RE: Field Issue of non-continuous post for covered deck and attachment of post to beam, support at "A" footing by stairs, and revision of braced wall panels for Lot # 114 Woodside Ridge – 129 NW Ambershame Dr. Lee's Summit, MO 64081– Permit # PRRES20204843

This letter addresses the non-continuous deck post and attachment of post to beam, support at "A" footing by stairs and revision of braced wall panels for Lot # 114 Woodside Ridge.

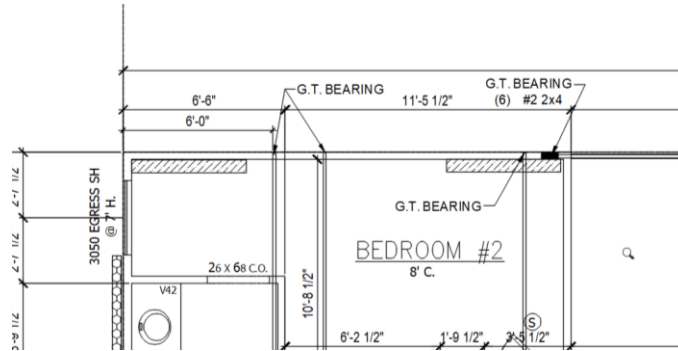
- Install (2) 16 ga. ST12 Simpson galvanized straps per post per manufacturer's specifications on both posts for deck and patio covering.
- Install with (10) 0.162 x 2-1/2 nails or Strong Drive Screws per manufacturer's specs.
- Straps shall be centered over post cut and installed on opposite sides of post.

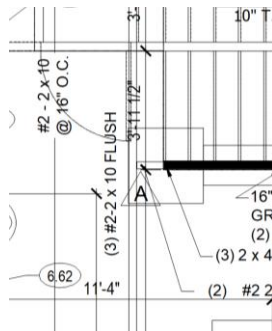
- Install (2) LIB braced wall panels at interior of bedroom #2 as shown in image below per 2018 IRC. WSP panels at bedroom #2 shall be omitted.
